# Transmitter Spectral Mask and DWDM Black Link Spectral Specification Proposal

IEEE P802.3cw

March 25, 2021

# 802.3cw 0.9 draft Tx Spectrum

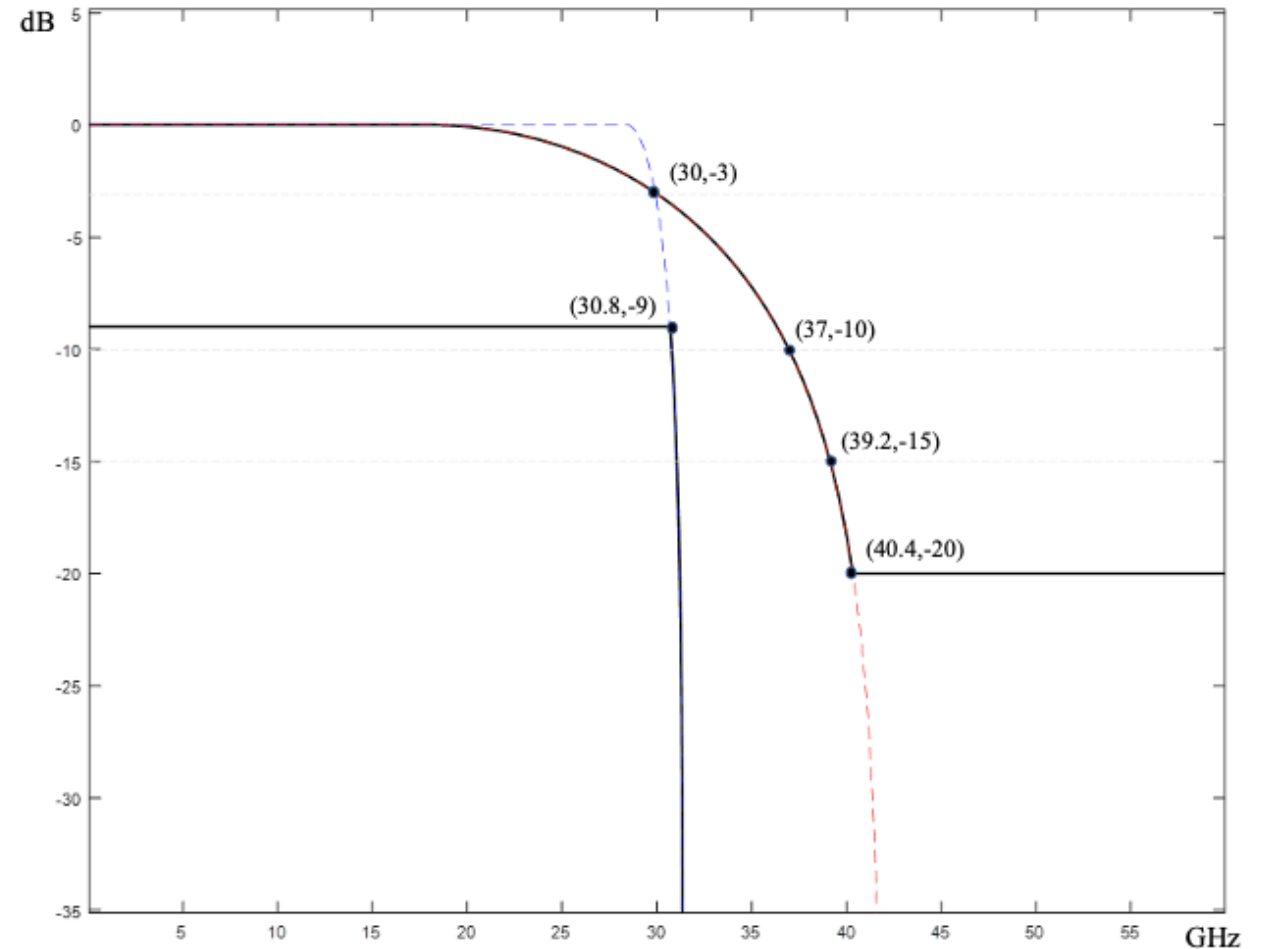
- 802.3 cw will specify:
  - The maximum Tx Spectrum based on an RRC curve
    - Roll-off ( $\beta$ ) = 0.4
    - Floor = -20dB
  - Defined as a continuous spectrum
    - Using discrete points can be discussed in the future
  - The minimum Tx Spectrum based on discrete points on an RRC curve
    - Roll-off ( $\beta$ ) = 0.05
    - Defined for attenuation > 9dB
- This is following the specifications in:  
[https://www.ieee802.org/3/ct/public/20\\_11/way\\_cw\\_01b\\_201116.pdf](https://www.ieee802.org/3/ct/public/20_11/way_cw_01b_201116.pdf)

The solid curves define the upper and lower limits of the mask.

Dashed lines show RRC with roll-offs 0.4 and 0.05

- Replace Spectral Excursion (max) (GHz) with:
  - Transmit Spectrum (max): 0.4 RRC Roll-Off
    - For frequencies > 3dB point
  - Transmit Spectrum (min): 0.05 RRC Roll-Off
    - For frequencies > 9dB point
  - Spectral Floor: -20 dB
- Some updates likely needed on definition for the mask, to include averaging of max

Define as continuous spectrum

- Spectral roll-off max defined for frequencies > 3dB point
- Spectral roll-off min defined for frequencies > 9dB point
